PCN #: 2635

PCN Title: Qualification of Additional Clip Bonding, Lead Frame Structure (Matrix) and Mold Compound for Select Discrete Products

PRODUCT CHANGE NOTICE

PCN-2635 REV1

Figure 1: Comparison of Package Construction

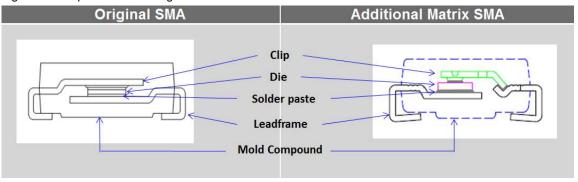
This PCN is being issued to notify customers that in order to assure continuity of supply and to improve assembly manufacturability, Diodes Incorporated has qualified additional clip bonding, lead frame structure (Matrix) and mold compound at Diodes subcontractor Eris Technology Corp. (ERIS) in Taiwan for select Discrete products.
